**Subject: Submittal of Amendment to the Prevention of Significant Deterioration
Application – Hydrogen Energy California**

Amendment to Prevention of Significant Deterioration (PSD) Permit Application

**Revised
Application for Certification
(08-AFC-8)
for
HYDROGEN ENERGY CALIFORNIA
Kern County, California**

Revised Figure 1-3 Preliminary Plot Plan

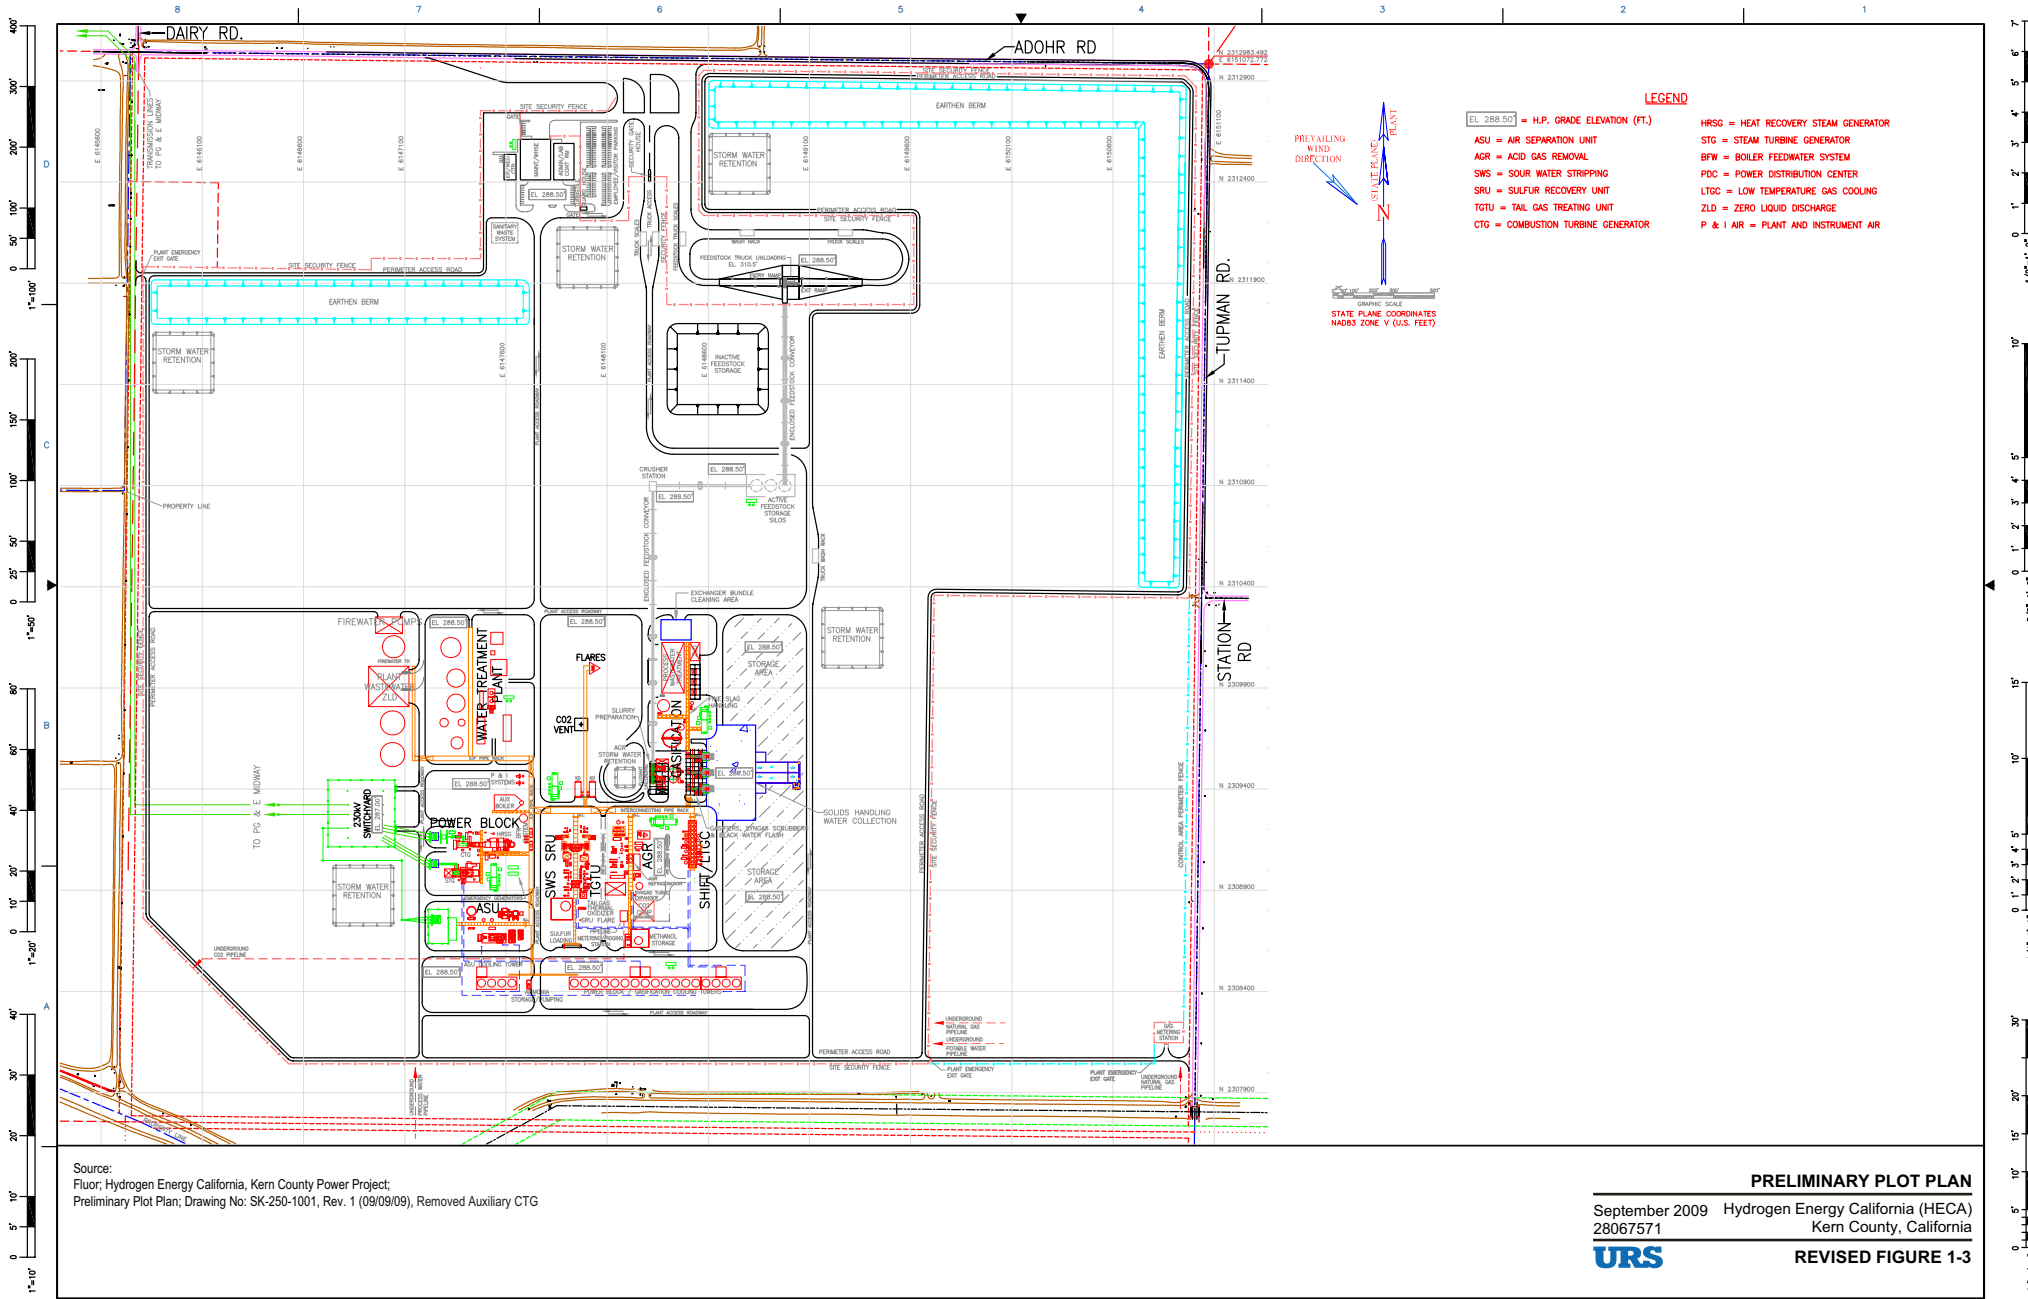
This Amendment presents information that has changed as a result of the Project modification. Tables and figures that have been changed as a result of this modification are included in this Amendment with the original table number, but prefaced with “Revised.” The Project modification is reflected in Revised Figure 1-3, Preliminary Plot Plan.

The Project modification consists of eliminating the auxiliary CTG General Electric (GE) LMS100[®] and reducing the emission rates for particulate matter less than 10 microns in diameter (PM₁₀) and particulate matter less than 2.5 microns in diameter (PM_{2.5}) from the GE Frame 7B CTG/Heat Recovery Steam Generator (HRSG) when firing hydrogen-rich fuel. Therefore, all references in the filed PSD to the following are no longer applicable: “auxiliary CTG,” “peaking power,” “auxiliary combustion turbine generator,” “GE LMS100[®],” “CTG-2,” “auxiliary Simple Cycle Gas Turbine,” “auxiliary Simple Cycle CTG,” and “turbines.”

Revised Figure 6-3 Locations of Maximum Predicted Ground Level Pollutant Concentrations
for the Operational Project Area

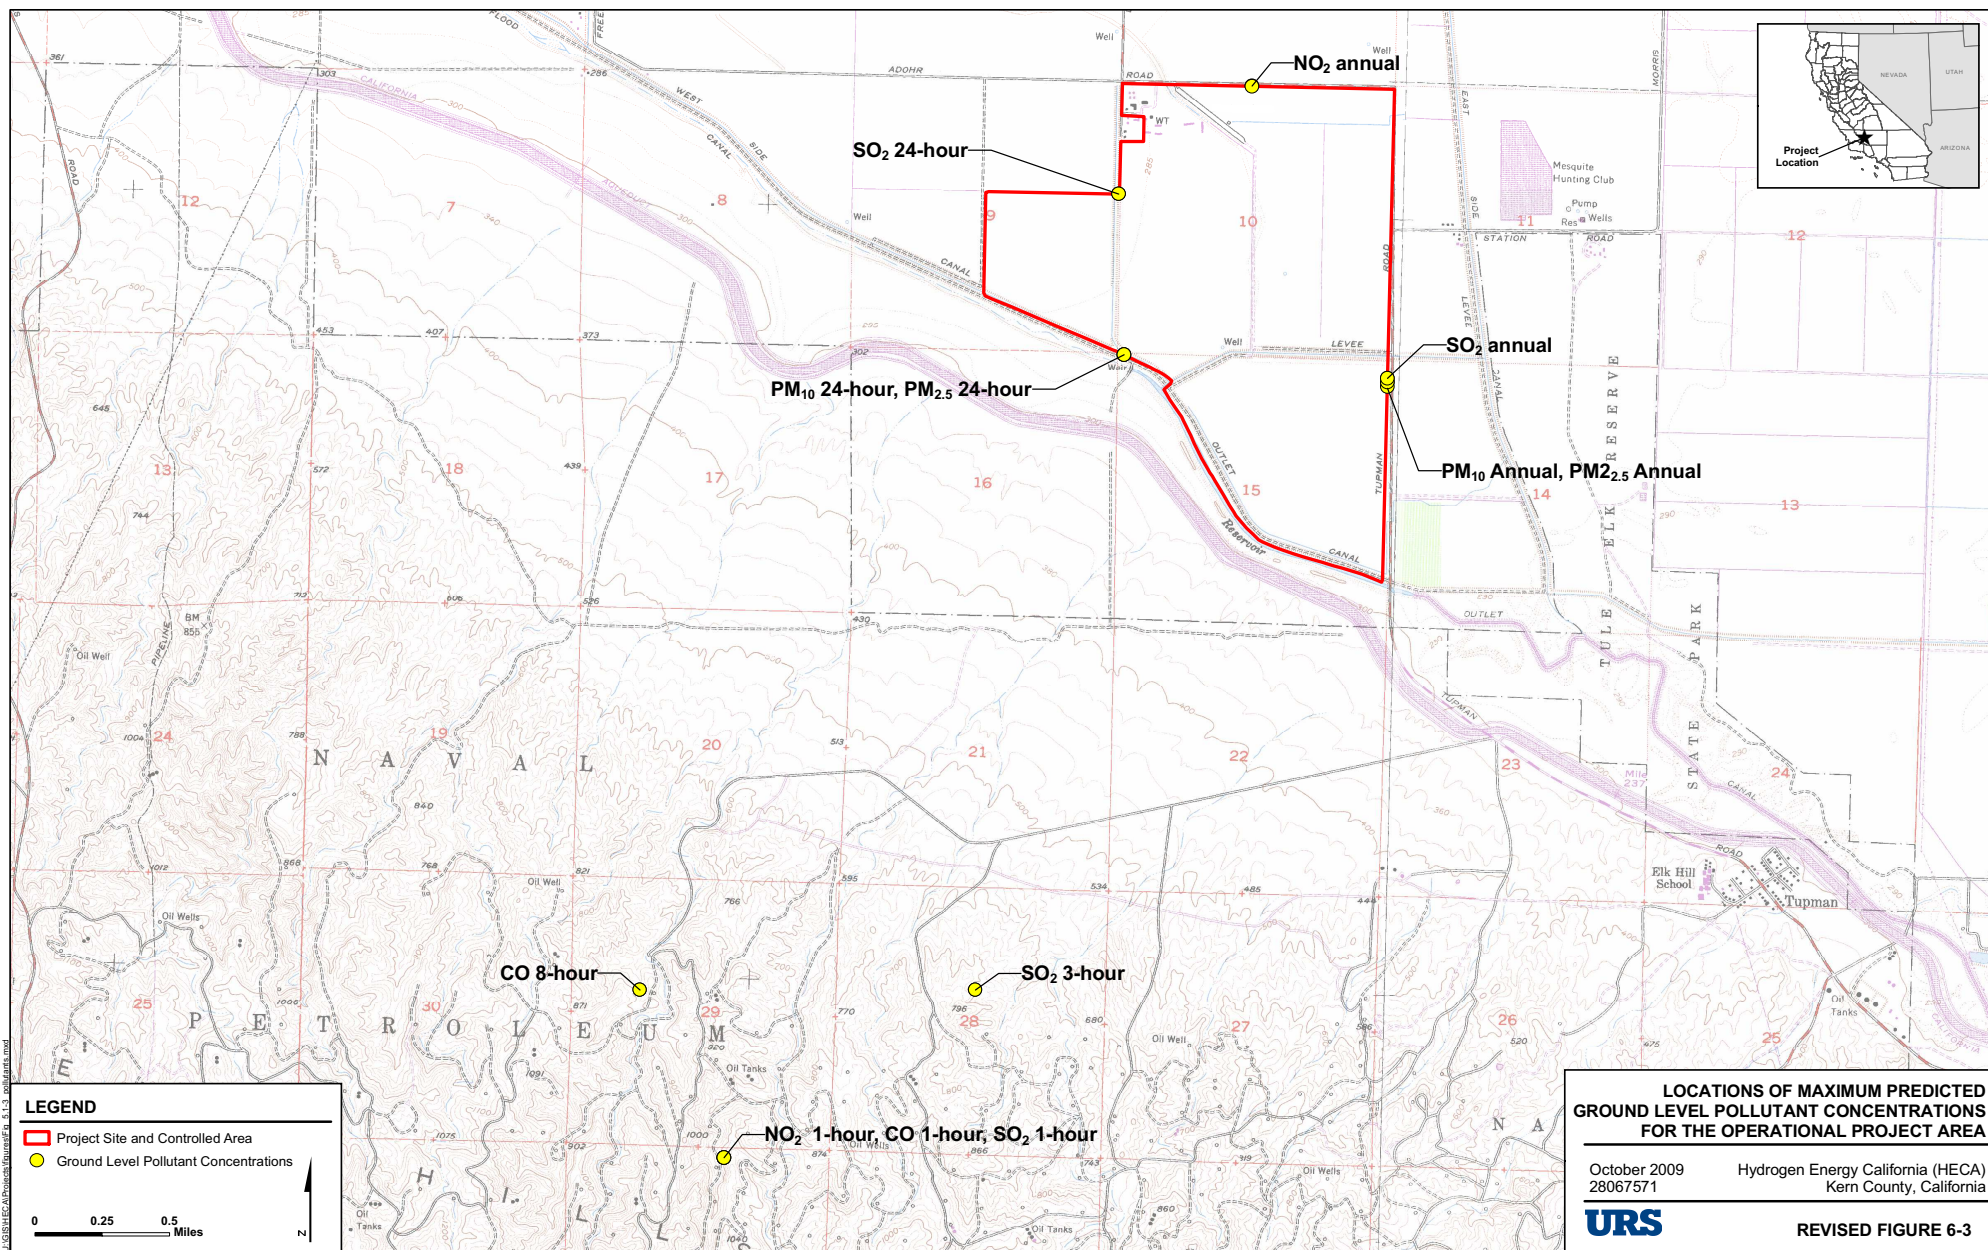
The locations of predicted maximum impacts will vary by pollutant and averaging time. Revised Figure 6-3, Locations of Maximum Predicted Ground Level Pollutant Concentrations for the Operational Project Area, shows the locations of the maximum predicted operational impacts for all pollutants and averaging times.

The peak 24 hour PM₁₀, PM_{2.5}, and SO₂ concentrations and peak SO₂ annual concentration are predicted to occur on the western boundary of the Project Site, while the peak annual PM₁₀ and PM_{2.5} concentrations are predicted to occur on the eastern boundary of the Project Site. The peak 1 hour NO_x, SO₂, and CO concentrations, peak 3 hour SO₂ concentration, and peak 8 hour CO concentration are predicted to occur within approximately 2 miles south of the Project Site. The peak annual NO_x concentration occurred at the northern property boundary.
